Date: Tue, 20 Mar 2001 16:31:58 -0500 (EST)
From: OET <oetech@fccsun07w.fcc.gov>
To: jmoulton@qcpi.com
Subject:

To: Jay Moulton, Kyocera Wireless Corp.
From: Joe Dichoso
jdichoso@fcc.gov
FCC Application Processing Branch

Re: FCC ID OVFPQP-3035A
Applicant: Kyocera Wireless Corp
Correspondence Reference Number: 18469
731 Confirmation Number: EA100274

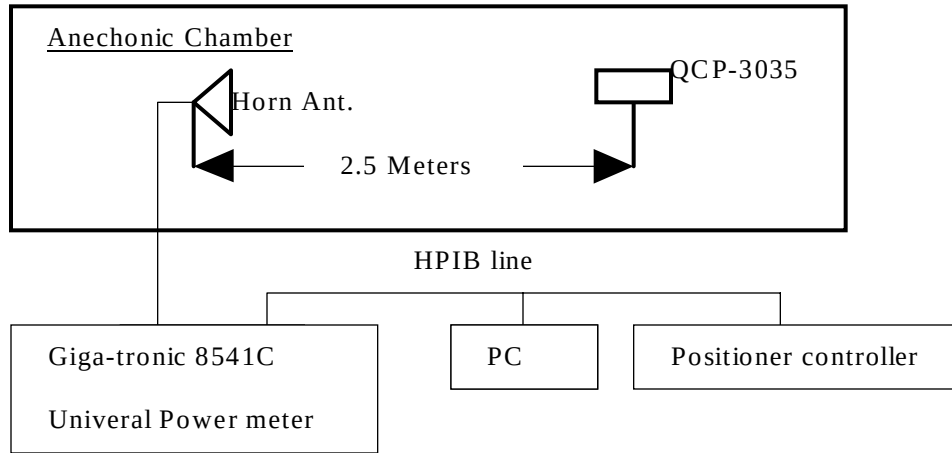
3) Resolve any output power output power discrepancies between the data in the radiated emissions exhibit, the SAR report and the test report and the requested output power. The ERP measurements in the test report incorrectly uses 49.8 instead of 49.2 for the ERP calculations. Please resolve/explain/correct all ERP and EIRP output powers. The requested output powers must agree with all exhibits.

3A) The original ERP and EIRP radiated output power amplitude levels were always correct, it was the test method in the original submittal report that was incorrect. The ERP and EIRP radiated output power was never measured on an OATS site. It was measured in an antenna range anechoic chamber. You can check in the original submittal data package and see that on page 12 of the SAR report the conducted output power and on page 13 the ERP and EIRP radiated output power that SAR was tested at. Kyocera always measures SAR with the phone set to an ERP and EIRP level that is 0.7 dB above the ERP and EIRP radiated output power that should be on the grant. This 0.7 dB is to insure compliance to SAR requirements with manufacturing tolerance. I have included the data sheets and test procedure.

The RF output power (**ERP**) was measured in an antenna range anechoic chamber.

carrier frequency (MHz)	channel	RF output power (W) – Cellular ERP Measured	
		FM	CDMA
824.04	991	0.646	
824.7	1013		0.479
836.49	383	0.537	0.407
848.31	777		0.407
848.97	799	0.513
